MFN 12-040

Subject: NRC Requests for Additional Information Related to the Audit of the Economic Simplified Boiling Water Reactor (ESBWR) Steam Dryer Design Methodology Supporting Chapter 3 of the ESBWR Design Control Document – Draft Versions

Draft Responses for RAI 3.9-274 and 3.9-277

Figure 1: Full penetration groove welded butt joint.

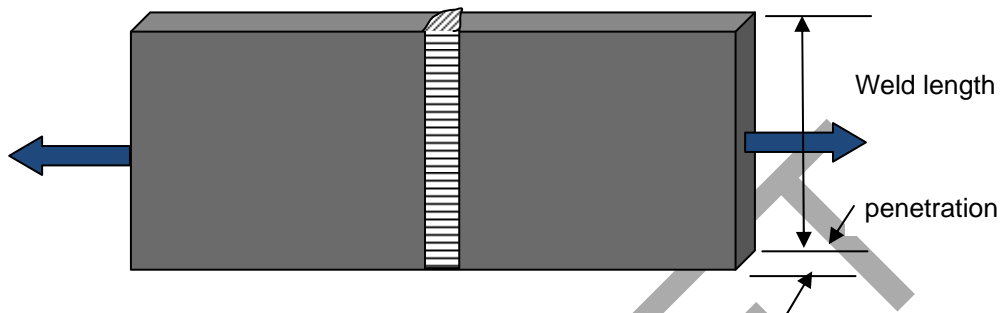
GEH is requested to discuss the use of specific types of welds in the ESBWR steam dryer and the justification for fatigue and quality factors for each weld type. In addition, GEH is requested to discuss the [] in the ESBWR steam dryer as described in NEDE 33313P, Rev 2. During the audit, the staff asked GEH to address the [] in the ESBWR steam dryer design, and how the [] will be conducted. At the audit, GEH made a definitive statement that the ESBWR steam dryer design []. The staff noted that this is inconsistent with NEDE 33313P, Rev 2. Please provide clarification if [] in the ESBWR steam dryer.

]. The effective weld area is based on the effective throat or joint penetration times the effective weld length. For full penetration, the joint penetration is the thickness of the thinner member being joined (see figure 1).
